STATEMENT IN RESPONSE TO THE SPECIFIC ADDITIONAL INFORMATION REQUESTED BY AN BORD PLEANÁLA

**PROPOSED STUDENT ACCOMMODATION LOCATED AT THE FORMER
RIALTO CINEMA, 355 SOUTH CIRCULAR ROAD, DUBLIN 8, D08 TX20**

2 August 2019

Figure 2.2: Extract of Drawing No. SB-2017-015-303 Rev. E, prepared by ShipseyBarry, which shows how the design of the scheme ensures that the adjoining residential amenity is preserved.

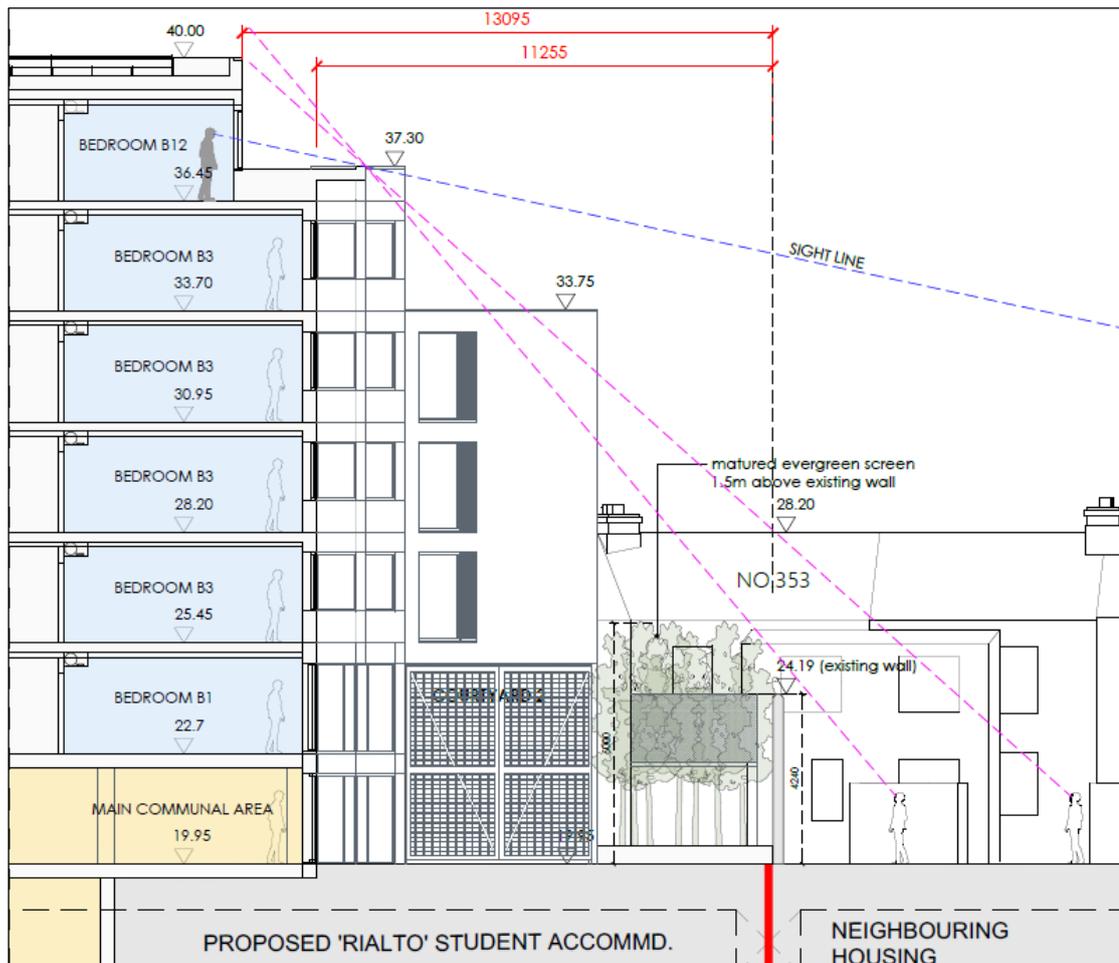
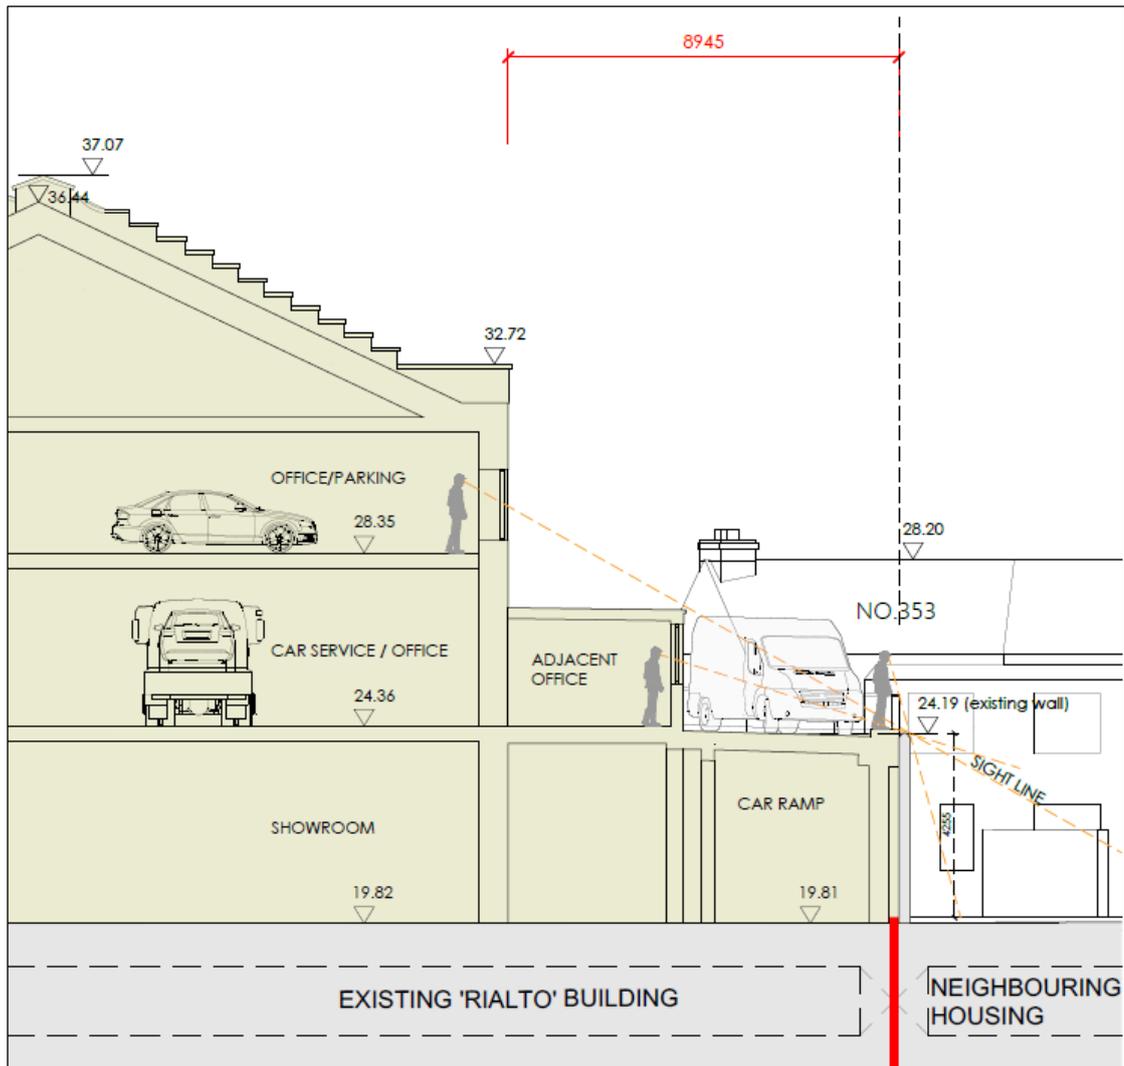
“A report that addresses residential amenity (both existing residents of adjoining developments and future occupants of the proposed student accommodation), specifically how the development will limit the potential for overlooking and overshadowing. This report should also include a sunlight and daylight analysis for both March and December.”

In addition, Drawing No. SB-2017-015-303, Rev. E prepared by ShipseyBarry demonstrates that the scheme has been designed in a manner that ensures that the privacy of adjoining residents is protected. Furthermore, we note that the proposal will significantly improve the privacy of adjoining residents compared to the existing situation, whereby from the top of the existing car ramp to the east, a person can directly overlook the rear garden of the adjoining houses (see Figures 2.2 and 2.3 below.)

Figure 2.3: Extract of Drawing No. SB-2017-015-303 Rev. E, prepared by ShipseyBarry, which shows how the existing building does not protect adjoining housing units from overlooking onto the rear garden.

Figure 2.4: Extract of Drawing No. SB-2017-015-401, Rev E, which shows the boundary treatment proposed along the western elevation.

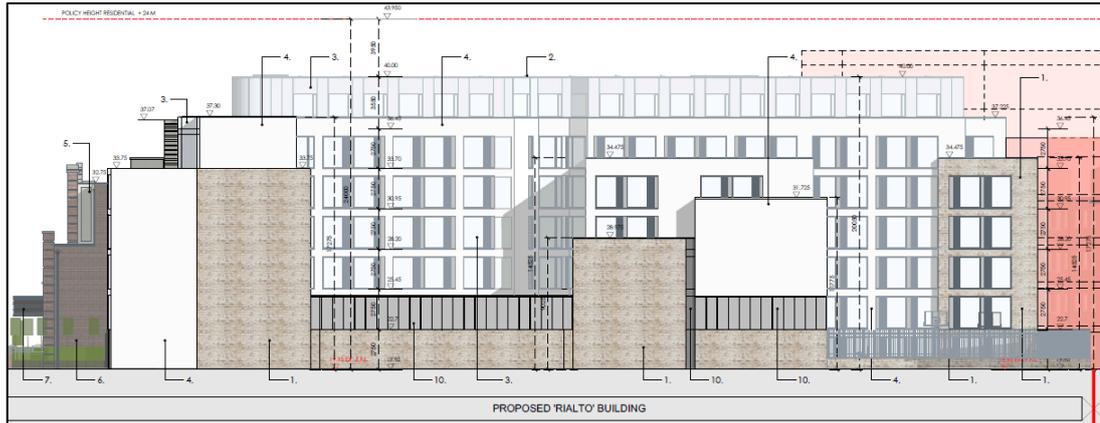
“Proposed boundary treatments should be specified having particular regard to need to protect existing residential amenities of the area.”

We refer to the *Landscape Plan* (Drawing No. 300 Rev. 2 prepared by The Big Space) and Drawings Nos. SB-2017-015-401, Rev E; and, SB-2017-015-402, Rev E, by ShipseyBarry, which illustrate the proposed boundary details.

Figure 2.5: Extract of drawing No. 300 Rev. 2 prepared by The Big Space showing the full extent of works proposed to the site frontage.

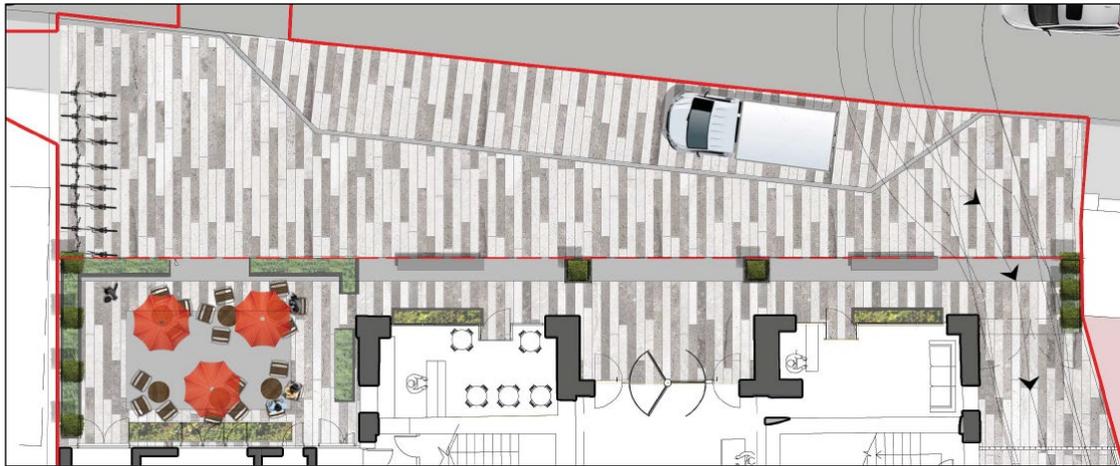
“A site layout plan which clearly identifies the full extent of works to the site frontage including provision of footpaths and whether the footpaths are to be taken in charge. Relevant consents to carry out works on lands that are not included within the red-line boundary. The prospective applicant is advised that all works should as far as possible be included within the red-line boundary.”

We refer to Drawing No. SB-2017-015-202 Rev. E, prepared by ShipseyBarry, and Drawing No. 300 Rev. 2 prepared by The Big Space for comprehensive details on the extent of works to the site frontage.
